CITY OF ASHLAND WATER POLLUTION CONTROL FACILITY

NO FEASIBLE ALTERNATIVE ANALYSIS REPORT FOR
ELIMINATION OF WPCF EQUALIZATION BASIN
OVERFLOWS

REVISED DECEMBER 20, 2022 (AFTER OEPA REVIEW)

Revised July 8, 2024 - Revised Implementation Plan and Schedule

Figure 7. 4. Removal of Overflow Volume as a Function of Additional Storage Volume Provided

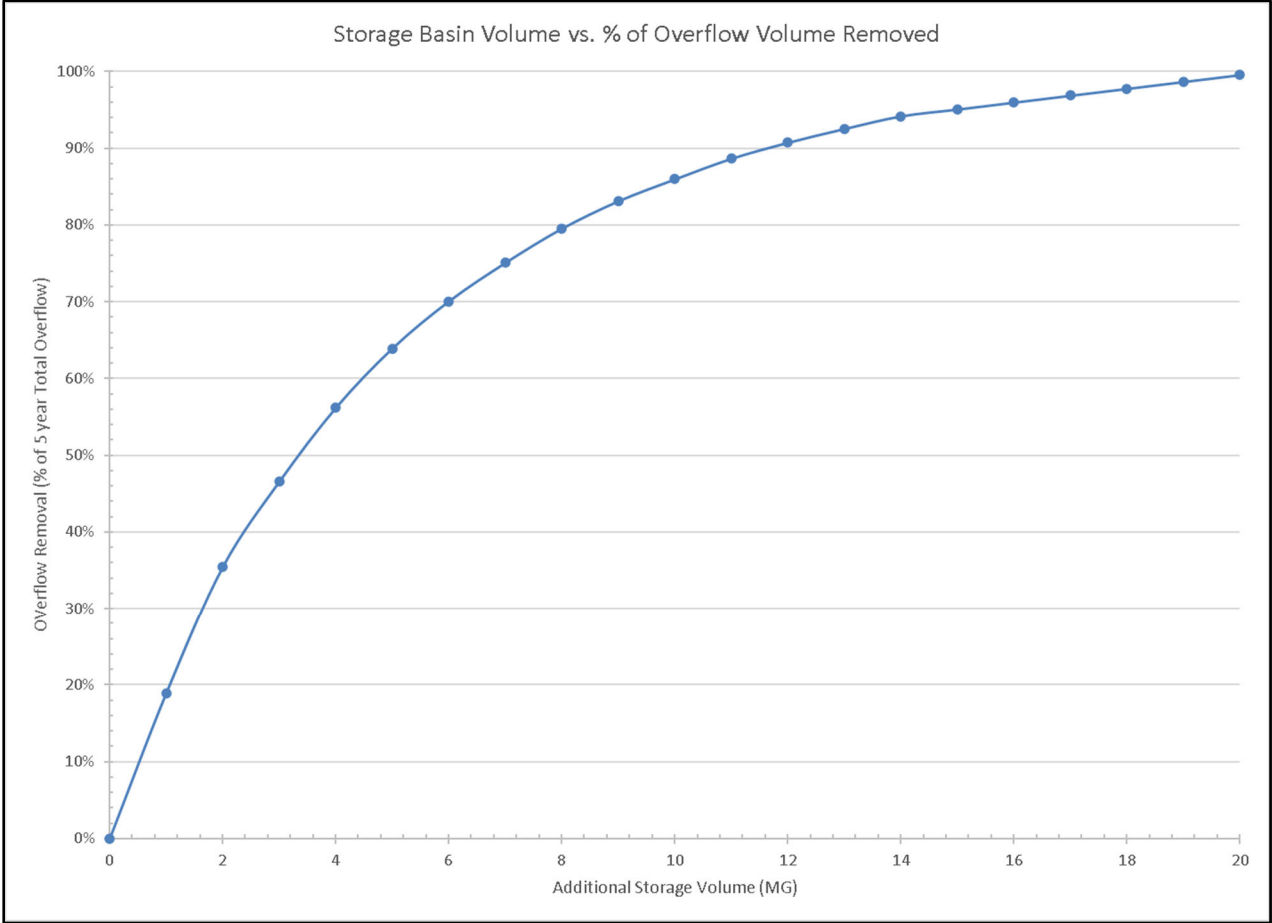
1. The NFA indicated that to remove all overflows from the 5-year period of storms reviewed, a storage volume of 20.5 million gallons (MG) would be needed. Based on the construction limitations, the plan recommends a 10 MG basin be installed and that this size basin would reduce the number of overflow events from 22 to 3 over the 5-year period reviewed. Please identify the largest storm recurrence interval that will be fully controlled by installation of a 10 MG basin, to serve as a design level of control.

Response: B&N reviewed the City of Ashland's available data (Monthly Operating Reports, as submitted to Ohio EPA and daily rain gauge totals). The two largest overflow events for the period of 2016 through 2021 occurred in June and July 2019. The June event was a longer duration event with substantial rainfall recorded for a 4-day period from June 15th through the 18th. The July event was shorter in duration, with rainfall recorded over a 2-day period (July 21st and July 22nd). The total overflow observed at the WWTP for the June event was 20.5 million gallons (MG). The total overflow observed for the July event was 13.8 MG. Without having hourly rain-gauge data, it is difficult to ascertain the exact frequency sizing of these events.
